STAFF RECOMMENDATION
3711 Whitland Avenue
January 18, 2017

Application: New construction – addition; Setback determination
District: Whitland Neighborhood Conservation Zoning Overlay
Council District: 24
Map and Parcel Number: 10409022100
Applicant: Kelly Motley, Owner
Project Lead: Sean Alexander, sean.alexander@nashville.gov

Description of Project: The applicant proposes to enlarge the house with a first story rear addition and a rear dormer. The project requires a determination for the appropriateness of a side setback shorter than the standard bulk zoning would require.

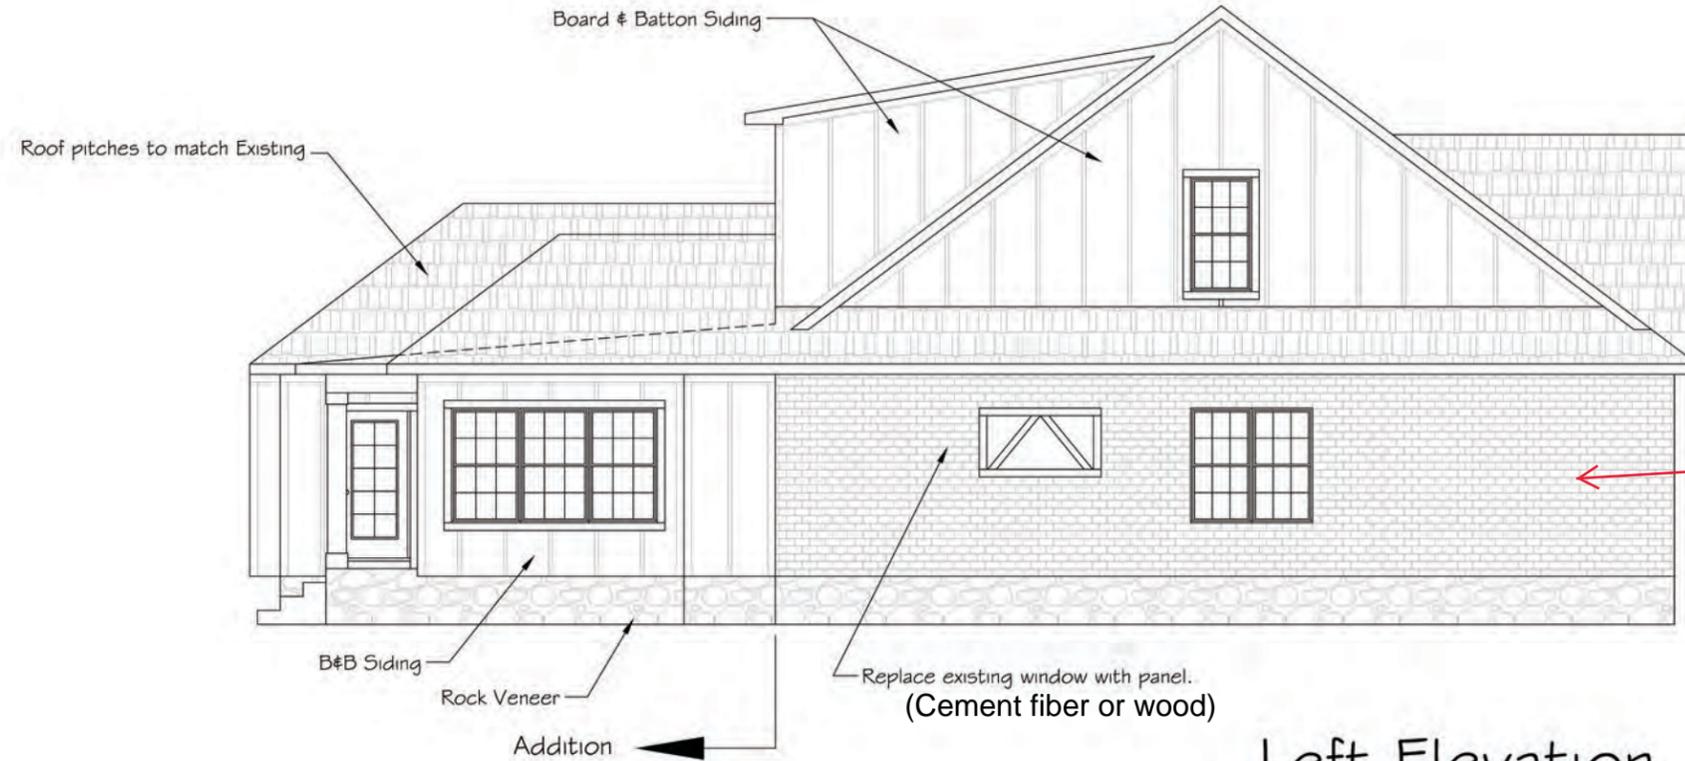
Setback & Rhythm of Spacing: The standard bulk zoning side setback requirement for this property is five feet (5'). The existing house, however, sits only two feet, six inches (2'-6") from the left side property line. The house is slightly angled on the lot so that even with the addition matching the width of the house, the left side will encroach two inches (2") further into the side setback buffer. Because of the way

the existing house is situated on the lot and the minimal further encroachment, and because shorter side setbacks are consistent with the historic development of the neighborhood, Staff finds the proposed two foot, four inch (2'-4") left side setback to be appropriate. The right side setback is greater than eleven feet (11') which meets the zoning requirements. Staff finds the proposal to meet II.B.1.c of the design guidelines.

Left Elevation

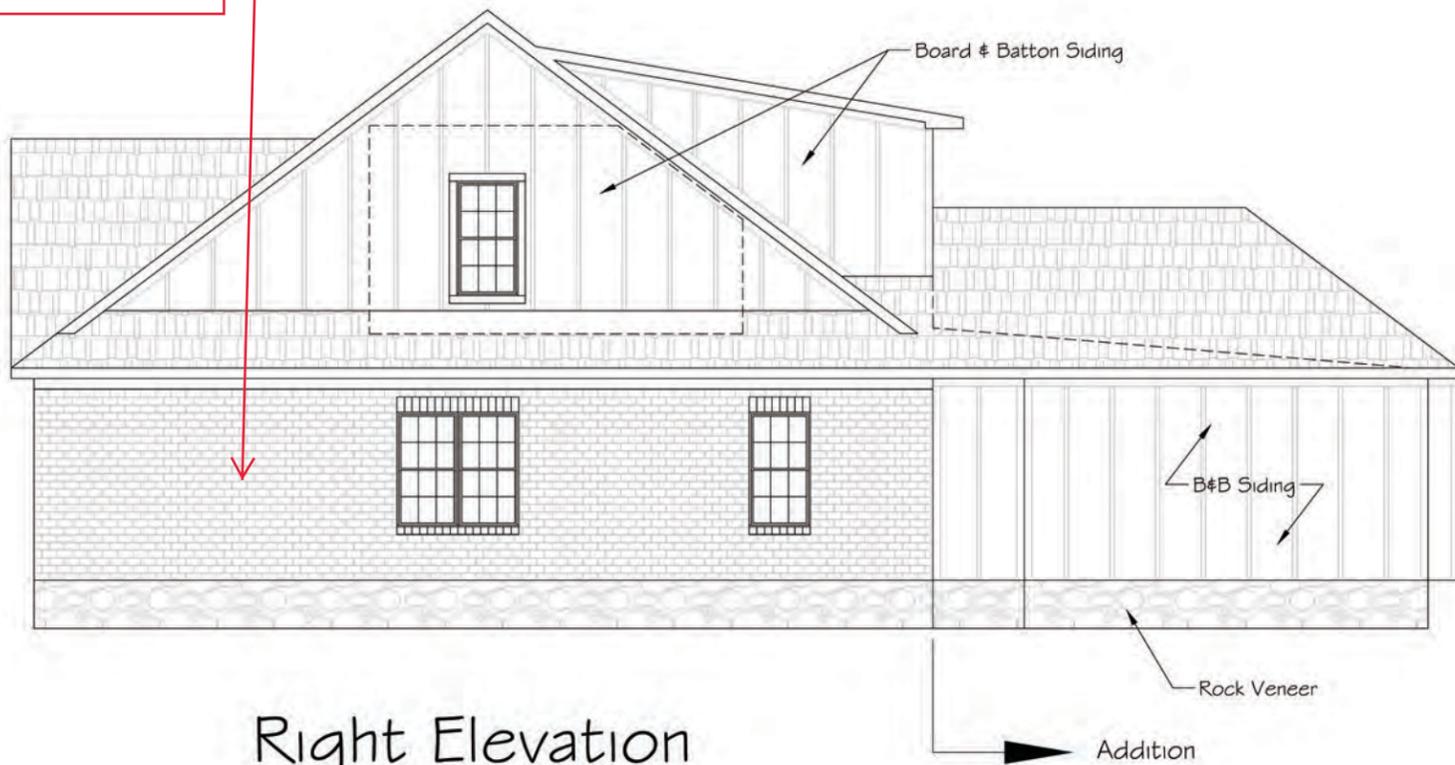
The plans show a window on the left side will be removed. The opening will be retained, filled with a cement-fiber panel. Altering original windows is generally not appropriate; however this window is located toward the rear on the side of the house with the shorter setback. For these reasons, Staff finds the window removal to be appropriate.

Existing window here not shown, will remain.
